<b>Notice of Allowability</b>	Application No.	Applicant(s)
	10/750,388	NETZEL ET AL.
	Examiner	Art Unit

### **EXAMINER'S AMENDMENT**

## Examiner's Proposed Drawing Correction

Fig. 4

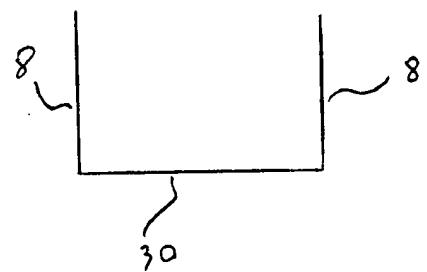
-- [0039.1] FIGURE 4 is a schematic representation of a handgrip in connection with closing levers. --.

-- Figure 4 shows a schematic in which connecting element 30, forming a handgrip, is connected to closing levers 8 located on both sides of the short circuiting device. --.

The proposed new drawings, Figures 4 and 5, filed on April 17, 2006, are not approved for entry because they are not fully supported by the originally filed disclosure. On the other hand, the examiner has provided an Examiner's Proposed Drawing Correction, including new Figure 4, which is considered to resolve the remaining objection to the instant drawings with respect to the features recited in instant claim 15. **Formal drawing is now required.**

Appl. No. 10/750,388  
Reply to Office action of Jan. 11, 2006  
New Sheet

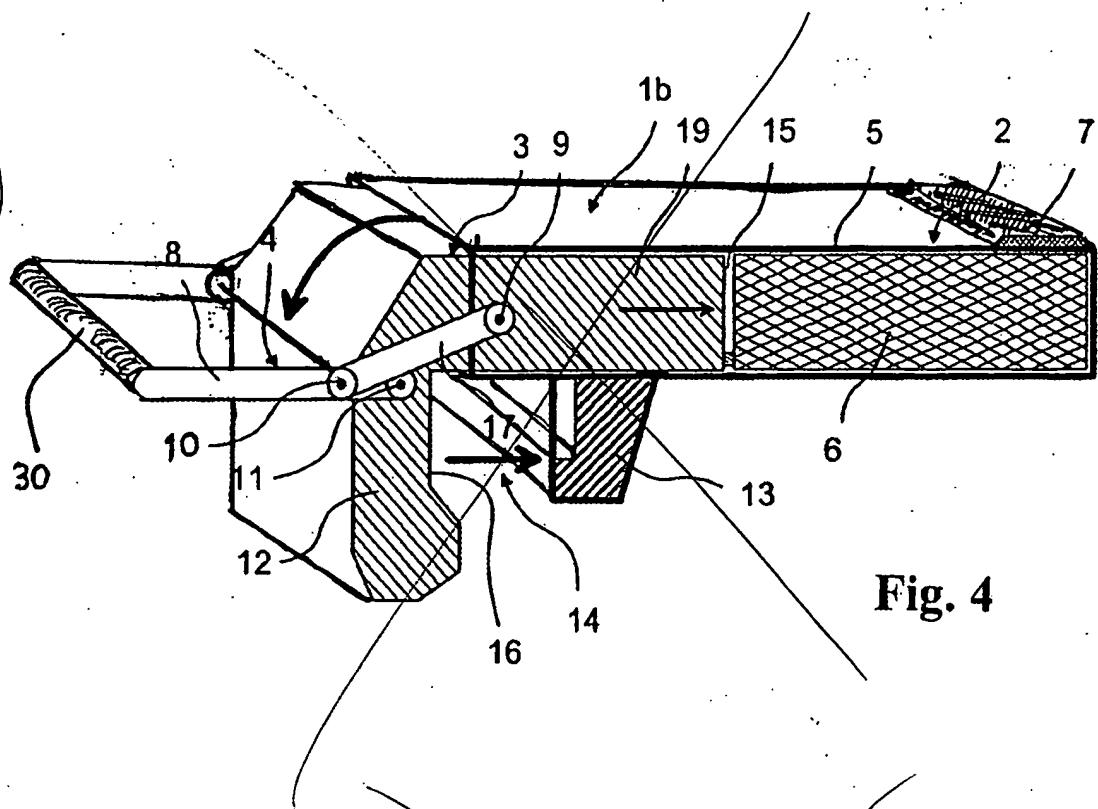
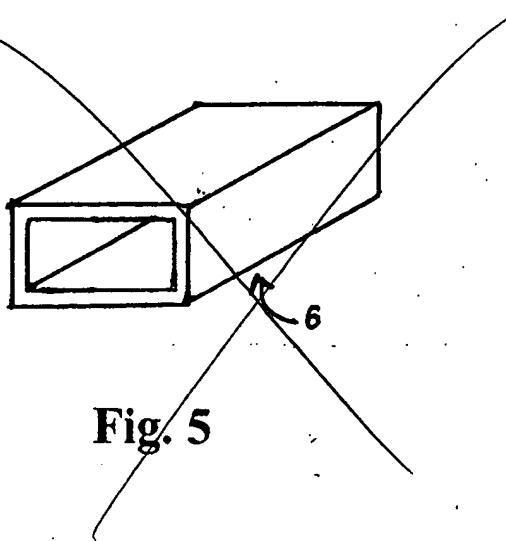
Entry  
not  
approved  
5/16/06
